Attachment 2  
Proposed Changes

Specification AC 7.1.2 - Plant Operations Review Committee (PORC,  
Administrative Controls

**FORT ST. VRAIN NUCLEAR GENERATING STATION  
ADMINISTRATIVE AND DEPARTMENTAL MANAGEMENT ORGANIZATION CHART**

FIGURE 7. 1 - 2

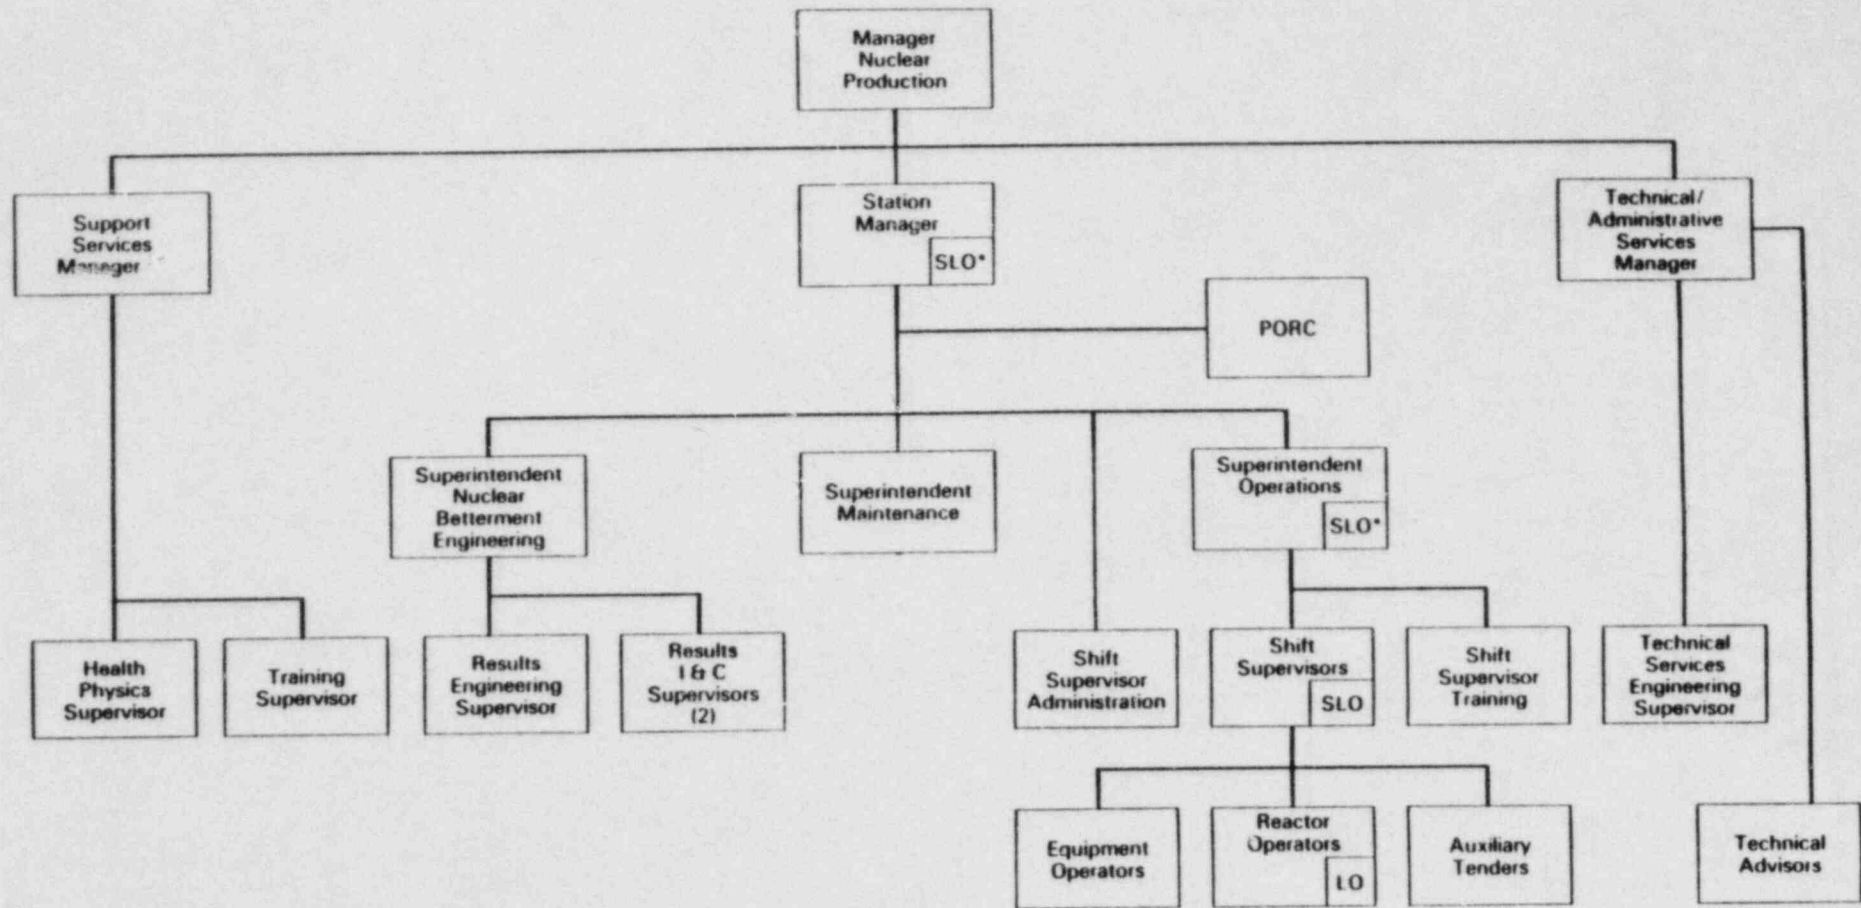
**FORT ST. VRAIN NUCLEAR GENERATING STATION  
CONDUCT OF OPERATIONS CHART**

- \* Either the Station Manager or the Superintendent of Operations shall possess a Senior License
- \*\* Serves as the Radiation Protection Manager
- PORC - Plant Operations Review Committee
- SLO - Senior Licensed Operator
- LO - Licensed Operator
